North Yorkshire Council

Thirsk and Malton Constituency Area Planning Committee

18 September 2025

ZE24/00112/MFUL - Erection of a retail unit (Class E) with associated car parking, access, hard and soft landscaping and associated works at land north of Commercial Street, Norton, North Yorkshire

Appendix C – Pedestrian Crossing

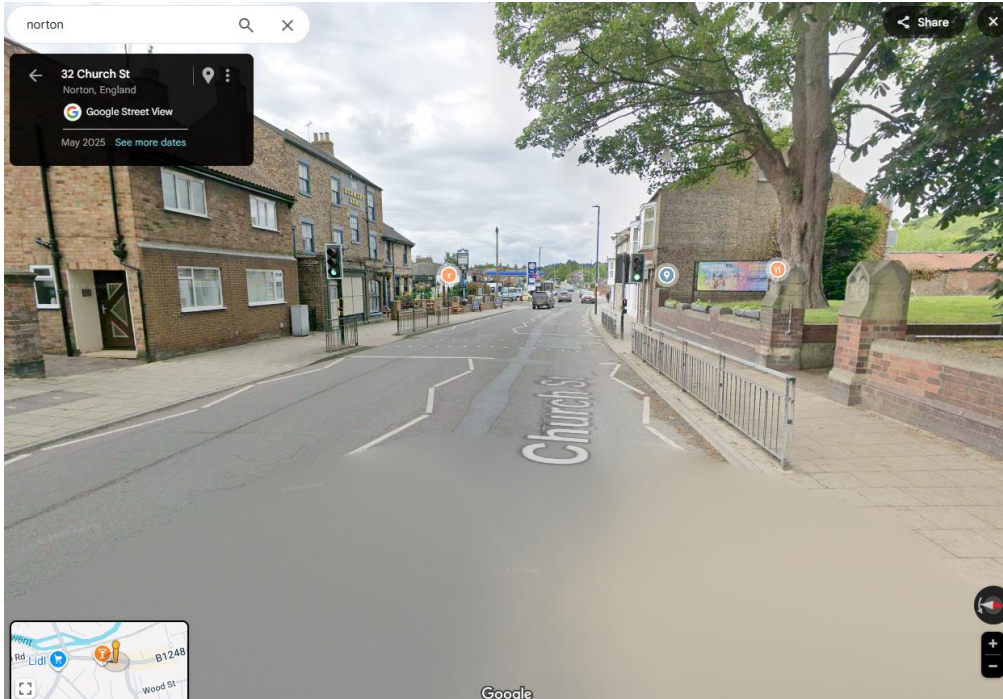
- Appendix C shows the location of the crossing outside Derwent Arms Pub where the committed £25,000 pedestrian crossing upgrade would be spent. This will be upgraded to LED/ELV for electrical safety and to reduce carbon emissions and maintenance cost, with fault monitoring included.

This will be to the east of the application site. It is the signalised crossing outside the Derwent Arms on Church Street that is to be improved, with the bus stop that is currently outside of the site being relocated to this area of Church Street, and the increase in footfall the crossing will see because of this. The contribution will enable to existing crossing to be upgraded to LED/ELV for electrical safety and to reduce carbon emissions/maintenance cost. A fault monitoring unit will also be installed so faults can be responded to quicker rather than relying on the general public.
